Transmit PSD mask

NXP Semiconductors

Warren, 16-17 April 2019

Summary of proposed modifications

PSD shapes with current PSD mask

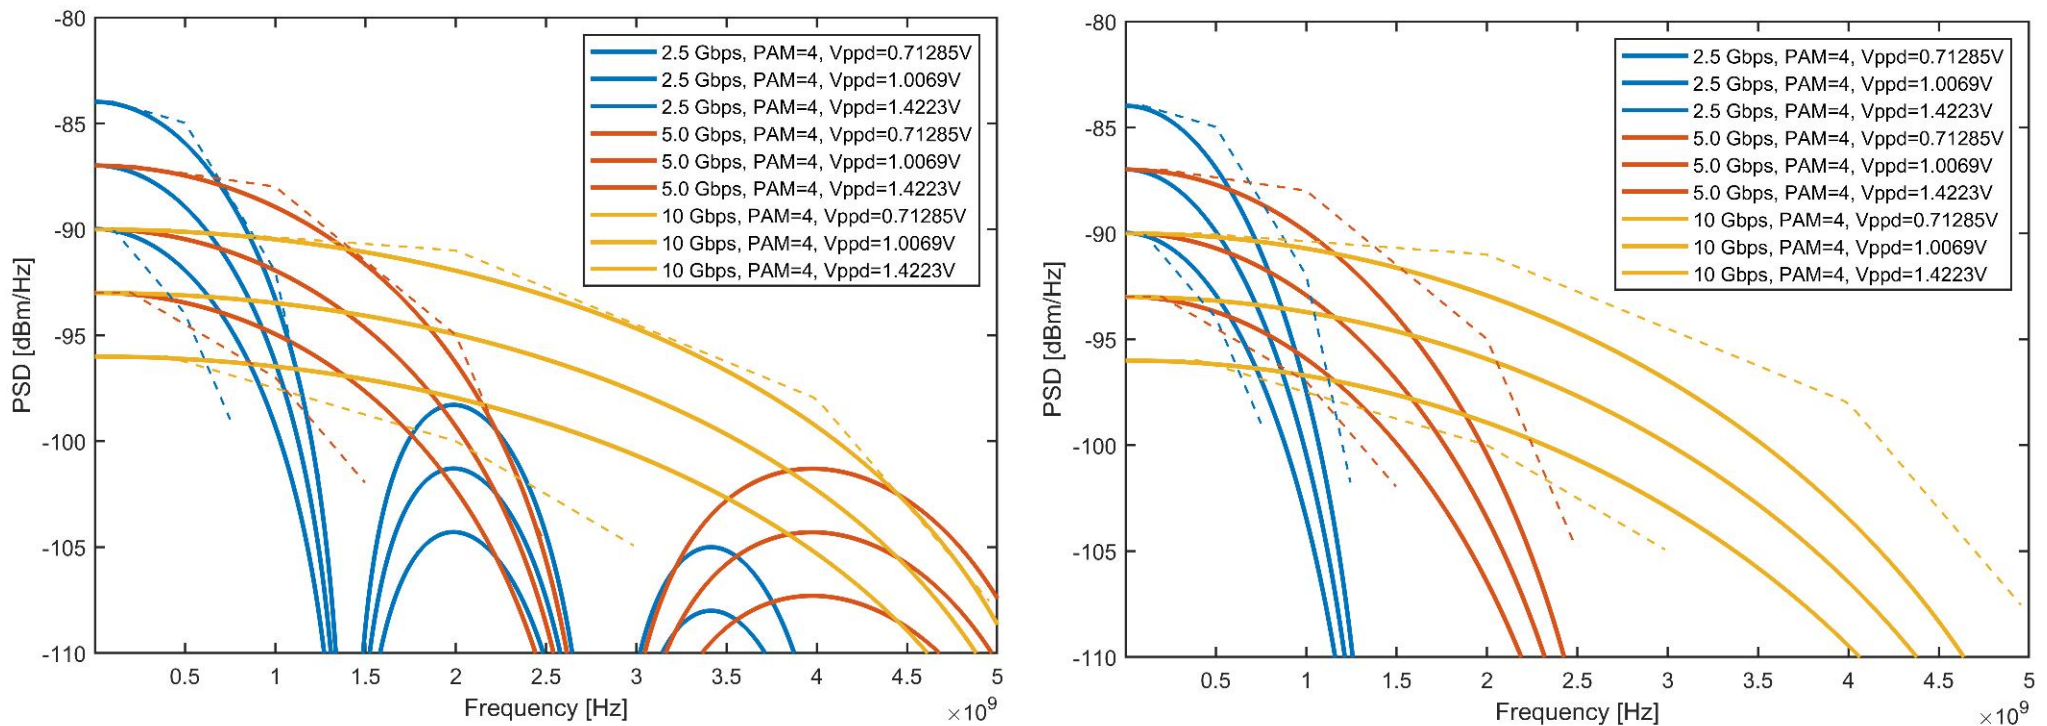
- ▶ Actual PSD shape shown for steep and smooth edges
- ▶ Current upper limit does not follow 'native' PSD shape
- ▶ PSD over the limit <2GHz for +3dB (implicit constraint)
- ▶ Limit above 2GHz is practically meaningless here

PSD shapes with proposed PSD mask

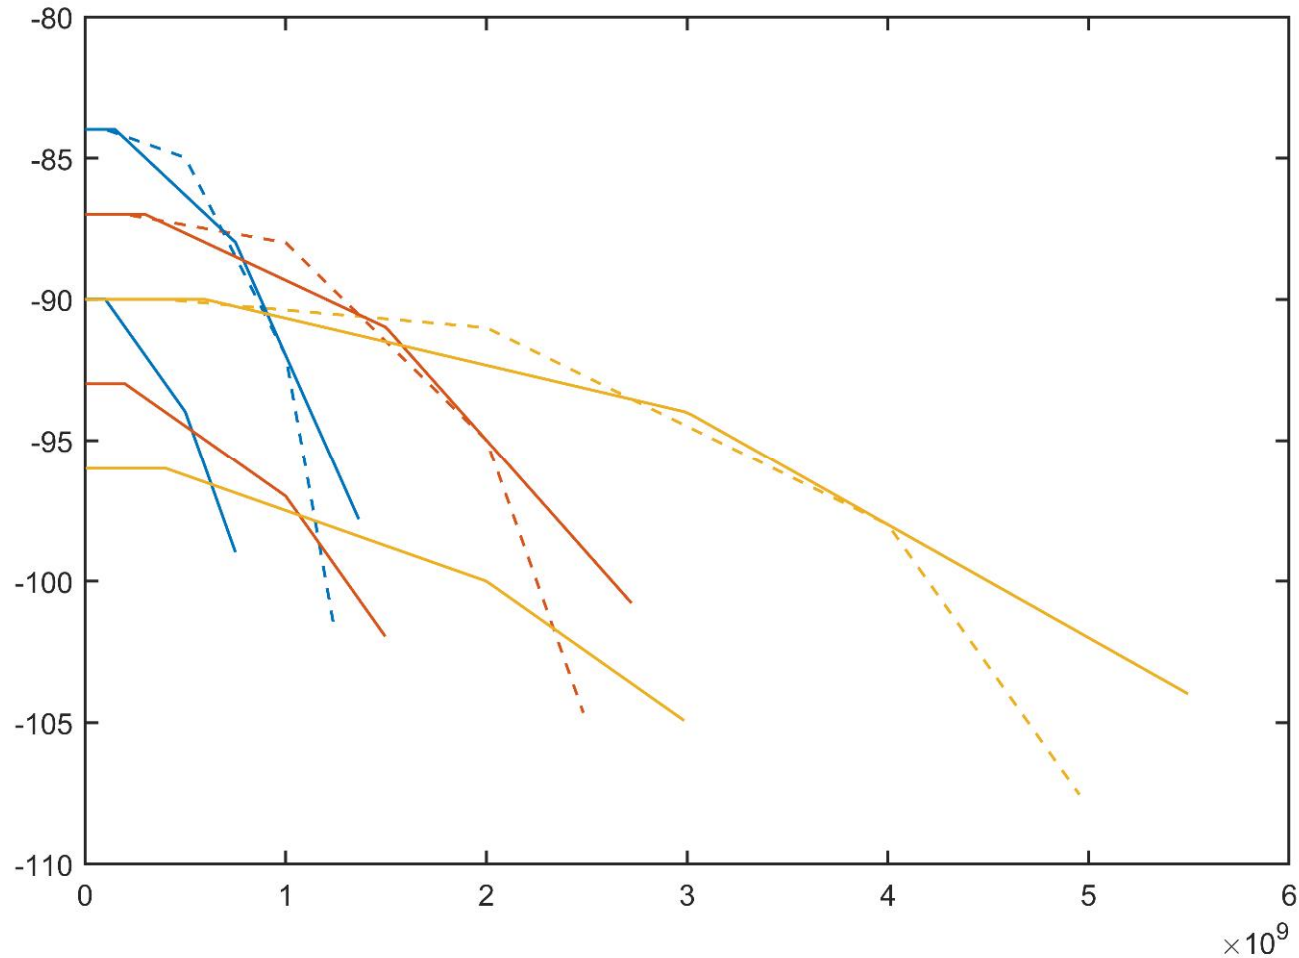
- ▶ Actual PSD shape shown for steep and smooth edges
- ▶ Proposed upper limit follows 'native' PSD shape

- ▶ Looser < 3S GHz, tighter >4S GHz
